Dixon Regional Watershed Joint Powers Authority

Re: Comments on the Dixon Downs Draft Environmental Impact Report

**RECOMMENDED ACCESS ON DIXON
 DOWNS PARKWAY FOR PHASE 1 & 2**
 FIGURE 4.10-2

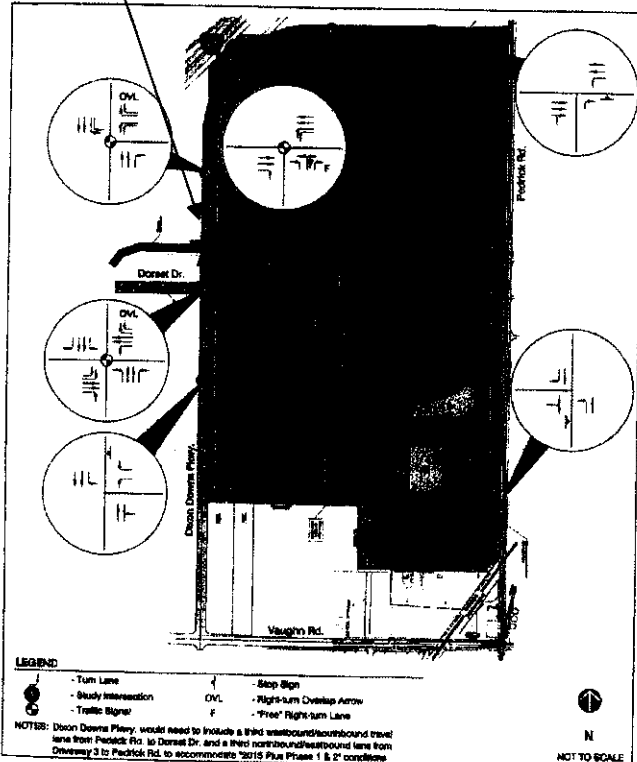
No consideration of existing, recorded IOD representing anticipated alignment of Dorset Drive.
